Re: Agenda Item 1 – Special Meeting of the Planning and Land Use Committee – Council File 21-0829-S1: (1) Corrected Resolution and Findings for a General Plan Amendment to the Venice Community Plan and the Certified Venice Local Coastal Program Land Use Plan (LUP) and (2) Report for the City Attorney and draft Ordinance Amending the Venice Coastal Zone Specific Plan to create a new Subarea A and establish new land use and development regulations by amending Section 10 of the Specific Plan, amending the Existing Zoning Map from OS-1XL and RD1.5 to (T)(Q)C2-1L-O, and amending the Existing Zoning Map to remove the proposed Alberta Avenue right-of-way between North Venice Boulevard and South Venice Boulevard, and replacing it with (T)(Q)C2-1LO; 2102-2120 S. Pacific Avenue, 116-128 E. Venice Blvd, 204-208 E. Venice Blvd, 214 E. Venice Blvd, 302 Venice Blvd, 301-319 E. Venice Blvd, 2106 S. Canal St, 200 E. Venice Blvd, 2106 S. Canal St, 210-212 E. Venice Blvd, 125 E. Venice Blvd. (VTT-82288; ENV-2018-6667-SE; CPC-2018-7344-GPAJ-VZCJ-HD-SP-SPP-CDP-MEL-SPR-PHP-1A; Related Council File Nos. 21-0829 and 22-0496)

At your request and authorization, we reviewed geotechnical and coastal documen

FIGURE 3 – Boat Launch Ramp Access with the Propose Project

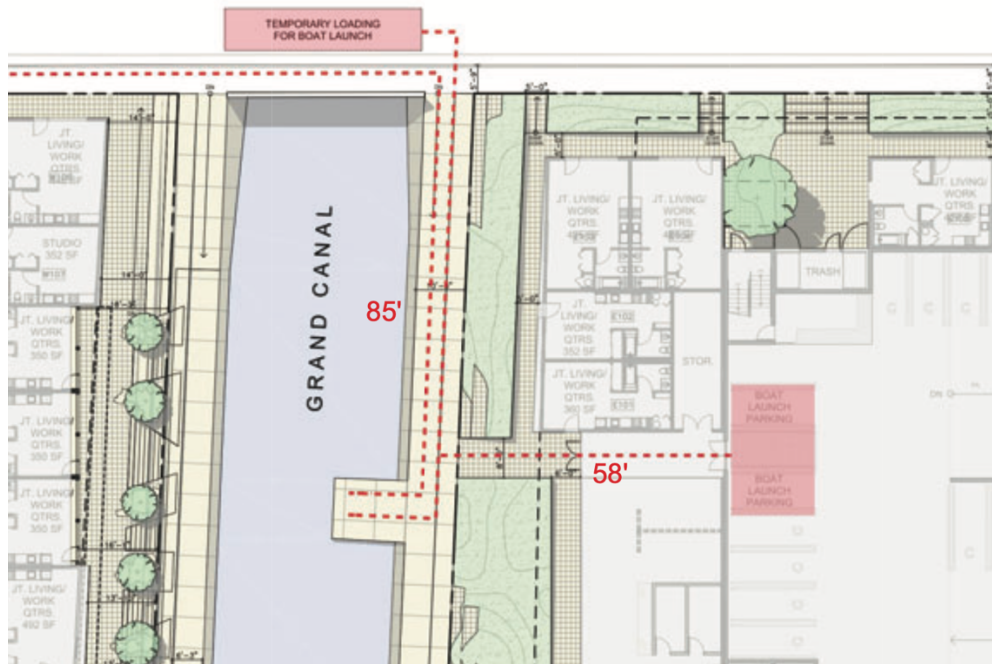
In contrast, as shown in **Figure 3**, with the proposed Project, access to the boat launch will be difficult, and may be impossible for some watercraft. As shown in **Figure 3**, the Project provides inside the east public parking garage two spaces for vehicles bringing boats to the Canal. These spaces appear to be standard parking spaces and are only 18 feet in length. In order for persons using these spaces, the boats must be small so they can be carried through two building doors and through landscaped areas to reach the boat launch.

These parking spaces do not serve boats transported on trailers. Not shown in Figure 3, a single “long” space for a vehicle and boat trailer is shown on the Exhibit A approved project plans for the west parking garage. Because this single space is located just inside the parking gate for the west garage, there is already concern that the location of the space is impossible to negotiate. Linked with this single space is a temporary loading zone space in the south lane of North Venice Boulevard, for long boats while loading and unloading. This will block a lane of traffic while unloading, loading and hanging out in the zone.

FIGURE 5 – Project Pedestrian Access for Beach Parking Users

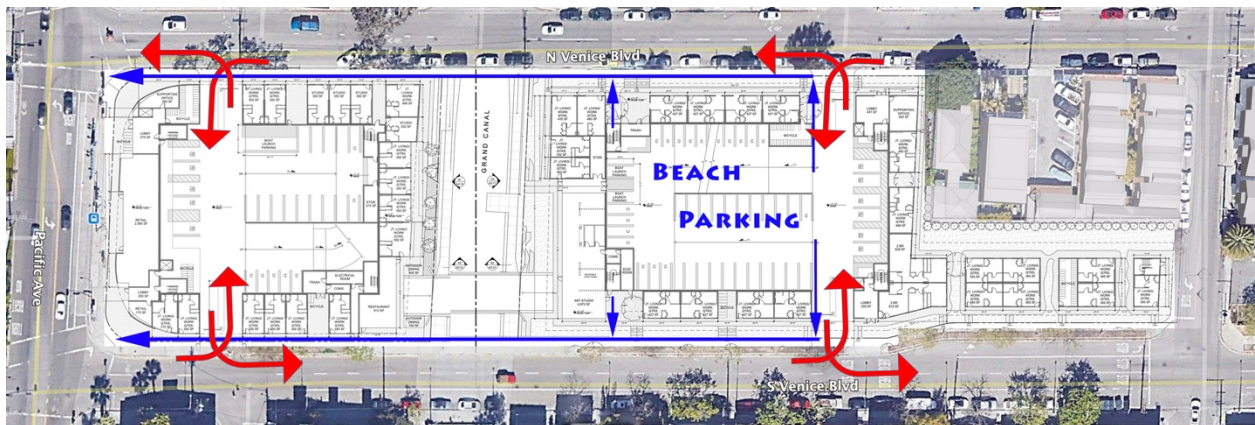
As shown in **Figure 5**, the proposed Project eliminates public parking on the western portion of the Project site thus moving 40% of beach parking 500 feet further from the beach, forces beachgoers to use the new eastern parking structure and to access crosswalks at Pacific Avenue by walking along the substandard (6-feet wide with obstructions) sidewalks on North and South Venice Boulevards, and to cross Project parking driveways. Changes resulting from the Project thus represents a beach access inconvenience and, to the degree that they decrease pedestrian safety, a public welfare impact.

Figure 1. Los Angeles County, Department of Public Works, Flood Zone Determination; 200 N. Venice Boulevard, April 21, 2021. FEMA Flood Zone AE, minimum base flood elevation (BFE) 8 ft NAVD88. Project site outline by red dashed line.

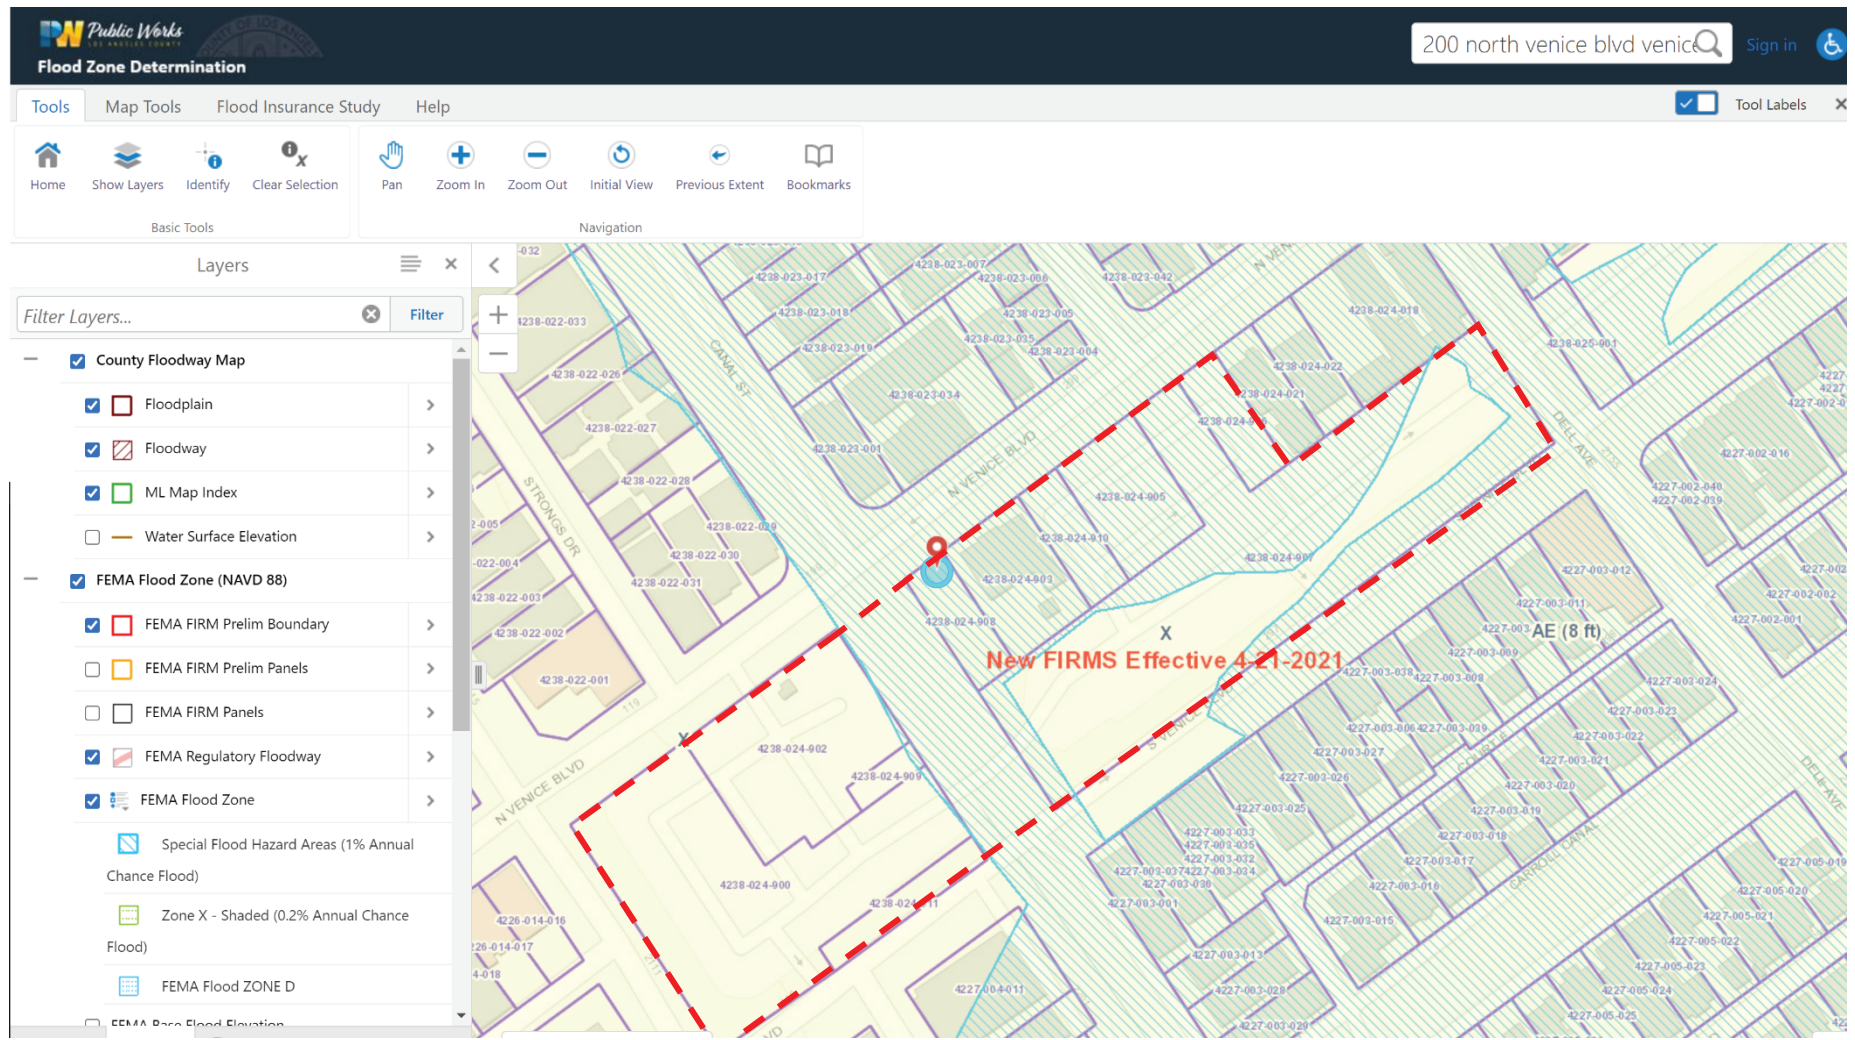
1. The GeoSoils Inc report on Sea Level Rise concludes that the site is not vulnerable to flooding. GSI (2020) references outdated FEMA Flood maps and the report findings and conclusion should be updated to reflect the newest maps released April 21, 2021. The project site is in a FEMA (2021) identified flood zone (AE) and has been identified as subject to potential future flooding because of sea level rise (depending on project life and risk aversion level). All finished floor elevation (FFE) recommendations should be updated and revised as appropriate as it appears the lowest design FFE (8.25 feet NAVD88) as stated by GSI (2020) is only 0.25 feet above the base flood elevation of 8 feet NAVD88 of the site and surrounding streets.
